NYCT COMPRESSOR DOOR HINGES REPLACEMENT

Prevost vehicles

On the vehicles affected by this bulletin, the compressor door hinges must be replaced by new improved hinges providing better door retention.

FIG.4 NEW UPPER HINGE

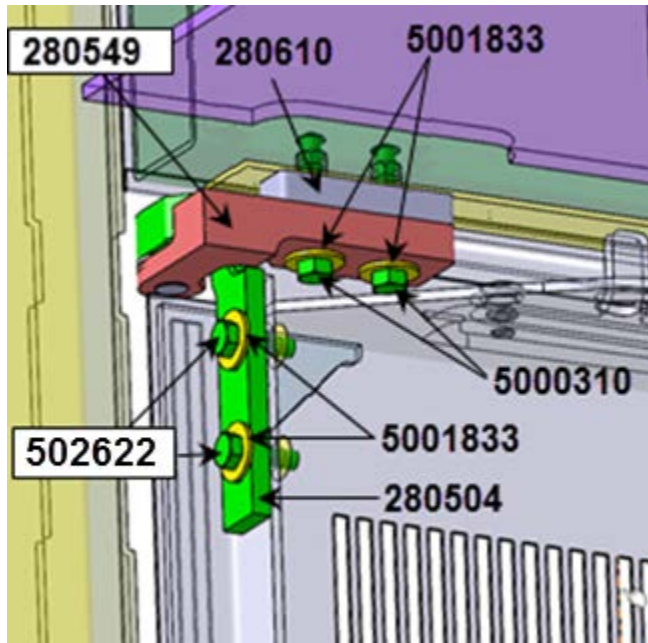
4. Install the new upper hinge (parts **280504**, **280549** & **280610** in kit Fig.4) making sure that:
 - New M6 bolts and washers (**5000310** & **5001833**) are used at the upper (vehicle structure) mounting points (Fig.4).
 - New M6 bolts (**502622** & **5001833**) are used at the door mounting points (Fig.4).
 - A new plastic bushing **284607** is installed at the pivot point (Fig.5).
 - The door is fully supported by the *lower hinge* and not slightly lifted-up by the lift table so there is no gap between parts at the lower pivot point (Fig.6).
 - There is no gap between the upper and lower part at the pivot point of the upper hinge (Fig.7).
 - The four M6 bolts are torqued to **68 lb-in** (apply blue Loctite 242 or equivalent medium strength thread locker on all fastener threads (Fig.8)).

FIG.12 NEW VS OLD LOWER HINGE PARTS

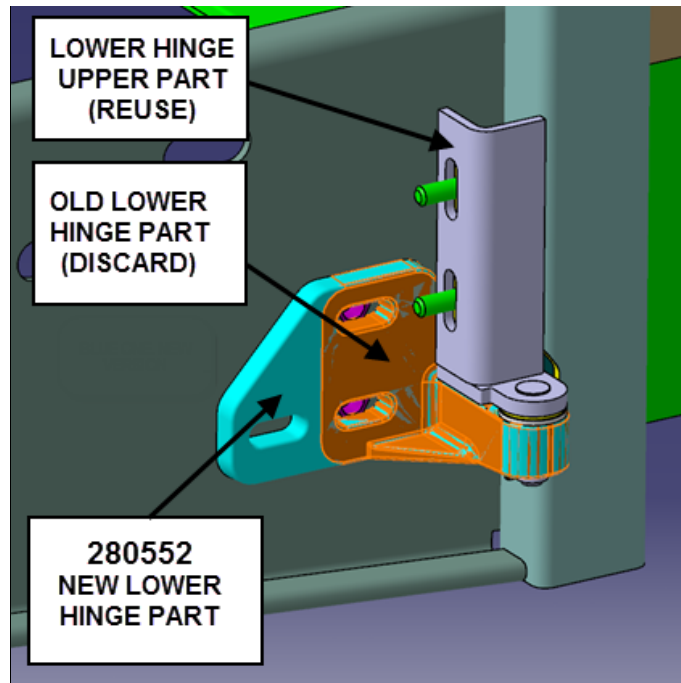
4. Discard the *lower* (vehicle structure) part of the lower hinge and replace it with the new **280552** part supplied with the kit (reuse the door part of the hinge but discard hardware Fig.12).

FIG.13 WASHER & BUSHING POSITION

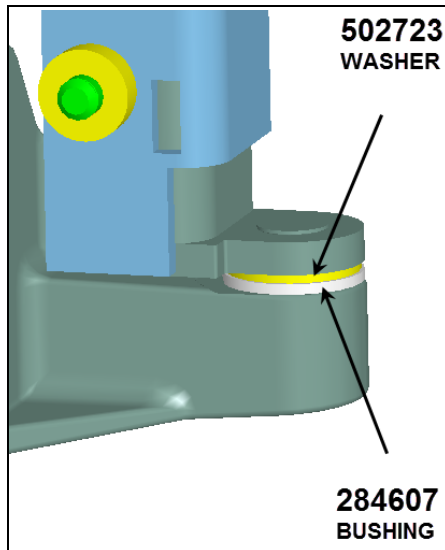
5. Reinstall the lower hinge (with new lower part) making sure that:
- New plastic bushing **284607** and washer **502723** are installed at the pivot point (Fig.13).
 - Door is fully supported by the *top hinge*, not the lift table (no gap at the pivot point) (Fig.14).
 - New M6 bolts and washers (**5001697 & 5001833**) are used at the door mounting points (Fig.15).
 - New M6 bolts, locks & washers (**502686, 502570 & 430406**) are used at the vehicle structure point (Fig.15).
 - All four lower hinge bolts (vehicle *and* door frame) are torqued to **68 lb-in** (apply blue Loctite 242 or equivalent medium strength thread locker on all fastener threads (Fig.16)).

FIG.19 LOWER HINGE 3rd BOLT HOLE

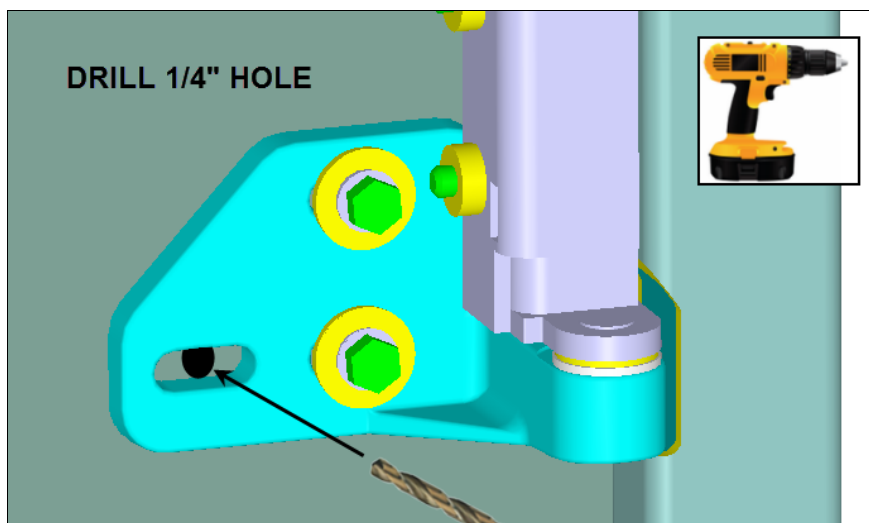
8. Drill a 1/4" hole in the middle of the lower hinge 3rd slot (Fig.19).

FIG.20 LOWER HINGE BOLT INSTALLATION & TIGHTENING TORQUE

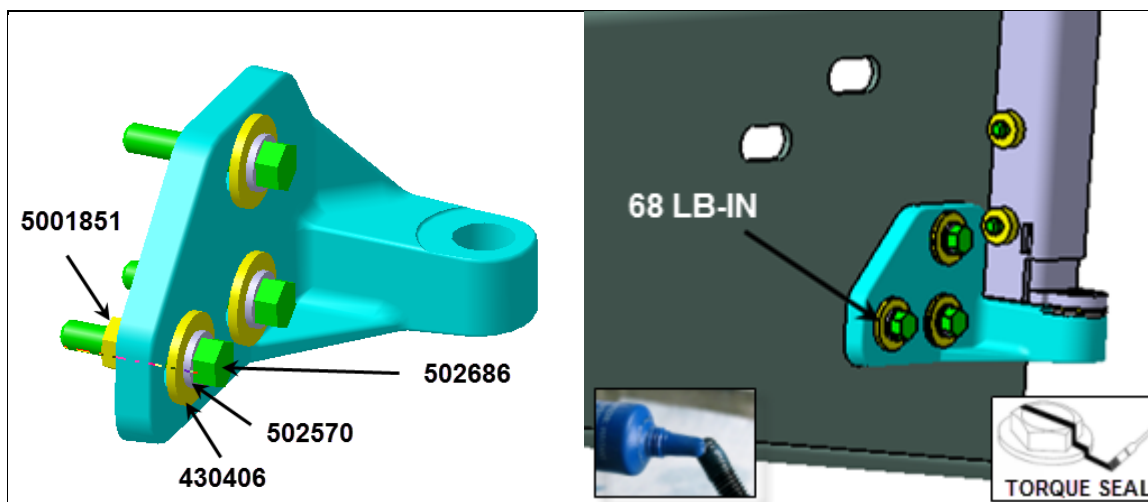
9. Install the supplied bolt **502686**, nut **500851**, washer **430406** and lock washer **502570** in the previously drilled hole, Apply medium strength threadlocker and torque to **68 lb-in**. Apply a stripe of tamper proof indicator paint (torque seal) to the bolt head (Fig.20).
